Glenelg Planning Scheme Amendment C15gelg
Dartmoor and Nelson Flood Study

Panel Report

22 July 2026

Dartmoor and Nelson Flood Study

Figure 2 Comparison of DEM and survey data

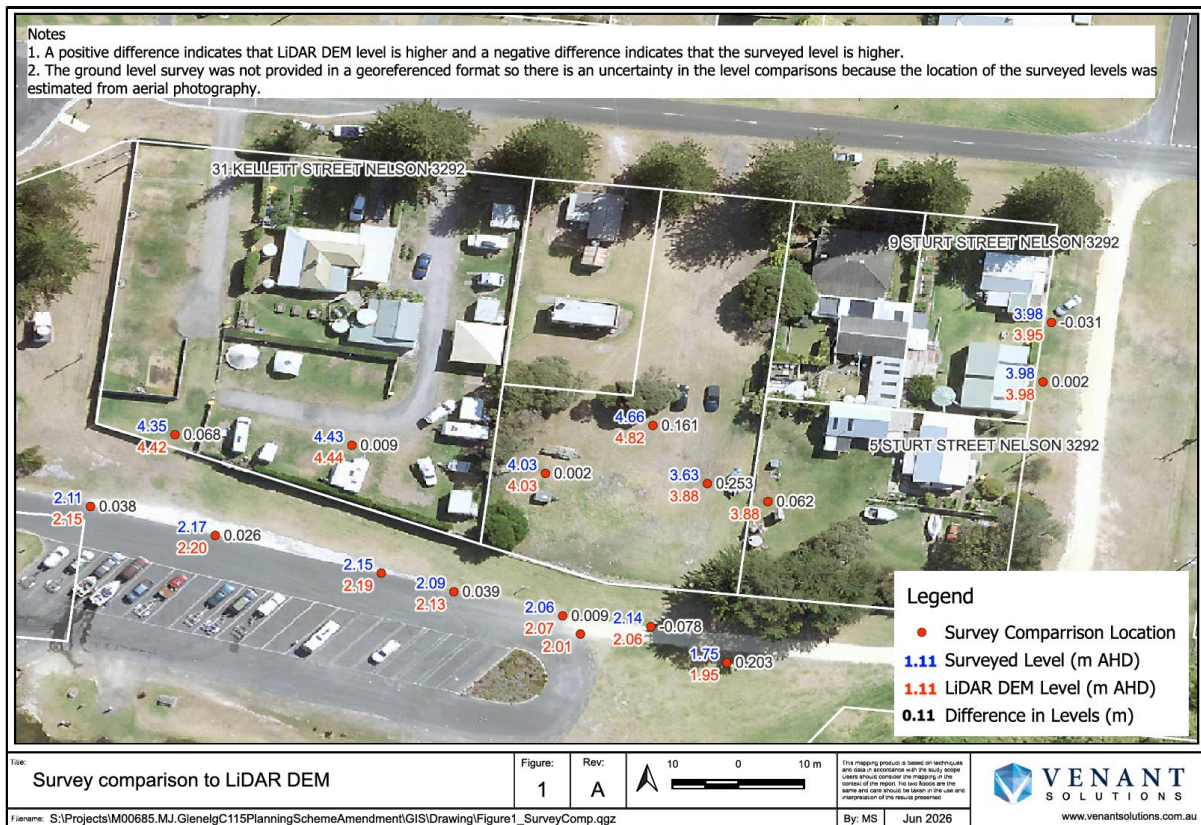
The Panel sought a table reconciling the model DEM elevation at each submitter's property against their licensed survey, identifying the dataset used and explaining any discrepancy. In response, Council provided the following information, provided by the GHCMA, to all parties after the Hearing ended (Document 11):

In addition, Council provided a figure comparing the DEM with the submitters' survey, showing the surveyed levels generally within ± 0.1 metres of the DEM (Figure 2).

Council advised that the GHCMA confirmed the '5 metre accuracy' figure was a misunderstanding of some submitters and a 5 metre DEM was used only in the South Australian reach where 1 metre coverage was unavailable, not at Nelson.

Dr Jempson gave evidence on behalf of Council which confirmed that 94 per cent of 156 check points were within ± 0.1 metres (mean $+0.04$ metres) and his formal comparison of the submitters' survey to the DEM showed that "*LiDAR represents the ground levels accurately, with levels generally being within the ± 0.1 metres*", which made it suitable for two-dimensional hydraulic flood modelling.

The Panel is satisfied that the topographic and survey basis of the Study is sound and that the reconciliation of the data sought has been provided. The Panel accepts Council's submission that the '5 metre accuracy' concern arises from a misreading of how the datasets were applied and the Nelson township, where the objecting properties are located, is covered by a 1 metre LiDAR verified to ± 0.1 metres. The submitters' own surveys do not contradict the model terrain, with the formal comparison showing them to be consistent with it, or where they differ, slightly lower than the DEM, which would tend to increase modelled depth at those properties.
